September 22, 2023

Teton County Idaho  
Jade Krueger  
Planning Administrator  
jkrueger@co.teton.id.us

**RE: Response to Review of Irish Acres Subdivision Level I Nutrient-Pathogen Evaluation**

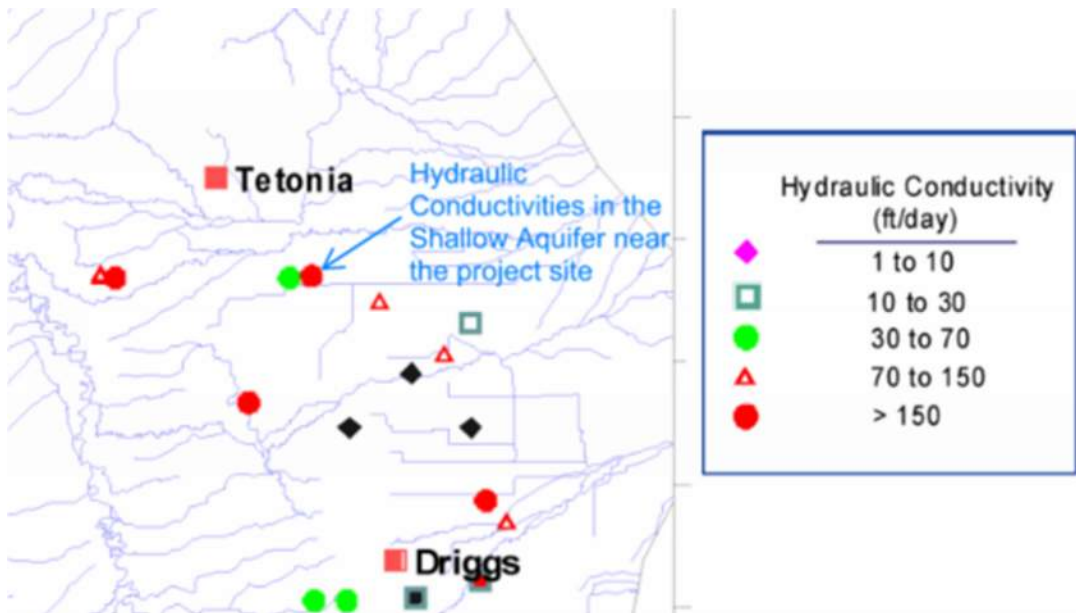
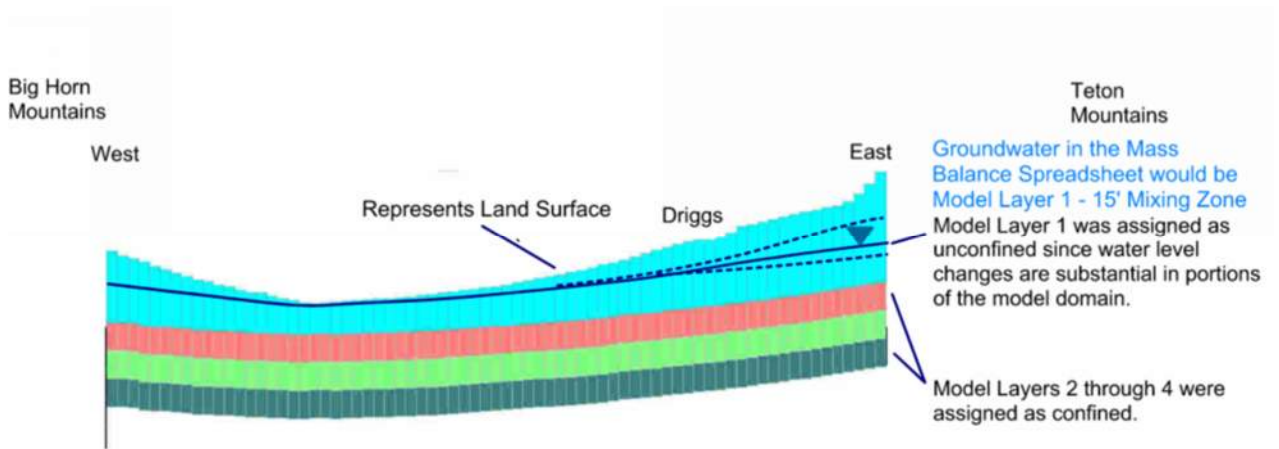
3. *Hydraulic Conductivity Estimate Above Reference Range:* The hydraulic conductivity used in all model simulations is 100 ft/day. Selection of this hydraulic conductivity value is not well supported. The author describes the 100ft/day value “conservative” for this use, noting that it is on the lower end of typical values for sand and gravel aquifers. The drilling logs cited and provided in the appendix make frequent mention of significant clay, which can greatly retard flow in porous media. There are several logs that have included pumping test data that could be used to infer a more supported hydraulic conductivity value. Evaluating this kind of existing data seems consistent with the Level I Nutrient-Pathogen criteria. Many of these rudimentary tests report production of 1 gallon per minute flow per foot of drawdown. While they lack rigorous description of methods or results, they should at least be compared with the assumed conductivity rate selected. The two best published estimates of conductivity covering this vicinity are from Nicklin (2003) and Cosgrove and Taylor (2007). Both of these assign values close to 25 ft/day for this location.

Three pump tests were found in the logs within ¼ mile of the project boundaries. The permit numbers for these wells are 702846, 702556 and 702847. Using the attached simplified hydraulic conductivity estimation

from Montana DEQ resulted in a range of hydraulic conductivities from 12 to 23 feet per day. As stated in the comment, the testing methods and results are not well documented. Also, the depth of pumping in these wells is much deeper than the mixing zone in the Nutrient Pathogen spreadsheet. There appear to be multiple layers in which hydraulic conductivity varies vertically. This is discussed further below in the review of the Nicklin report.

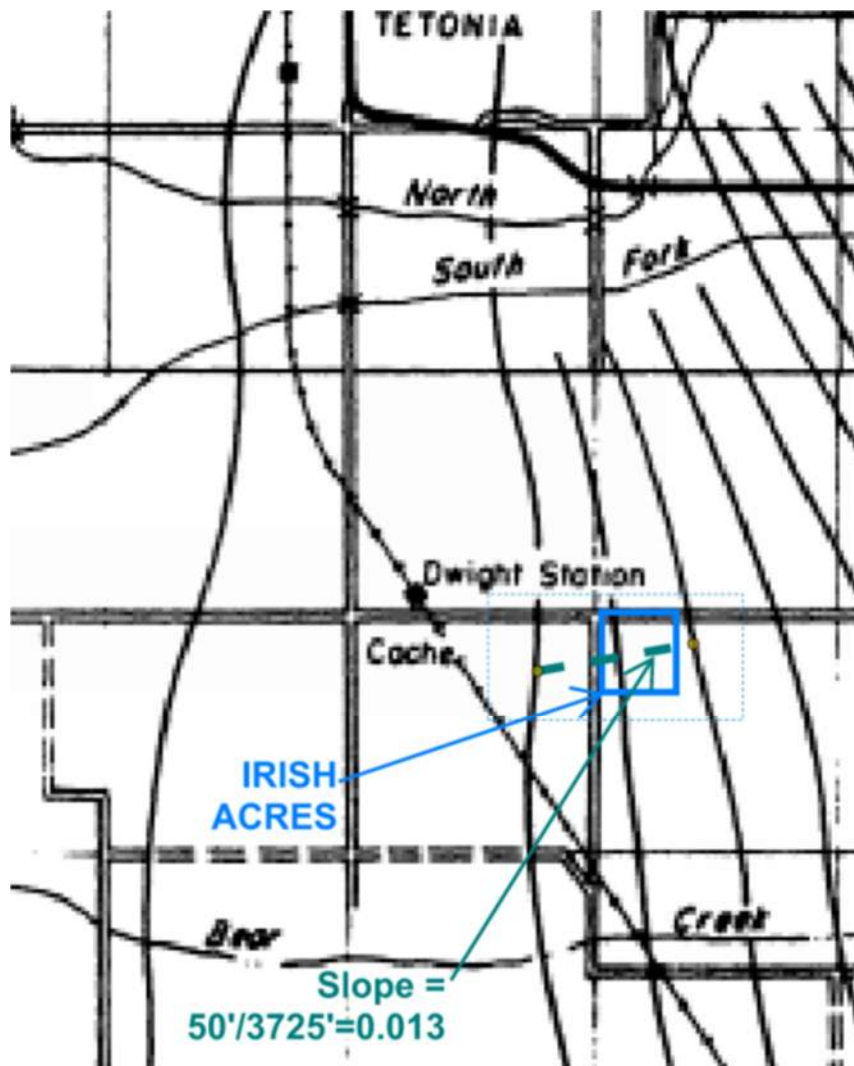
4. *Modeled Hydraulic Gradient Inconsistent with References:* The author assumes that the hydraulic gradient reflects the slope of the ground surface: 0.01 ft/ft. This generalized approximation seems a poor substitute for more specific references provided in mapping by Kilburn (1964), Nicklin (2003), and Cosgrove and Taylor (2007), which indicate that 0.006 is a representative value for this location. These maps do generally agree with the author’s assertion that the direction of groundwater flow is east to west.

**Response –** Nicklin (2003) states in section 4.1.6.3 that the hydraulic gradient assigned in their model ascertaining that the, “general flow direction is consistent with the land slope as typifies many basin aquifers”. Figure 22 of the report has the project area mapped with 50 feet of water level contours over 3,725 feet, or a slope of 0.013 ft/ft. This is consistent with the ground slope in the project area. The 0.013 ft/ft gradient as utilized in the updated Nutrient Pathogen Evaluation. Please see the excerpt below.
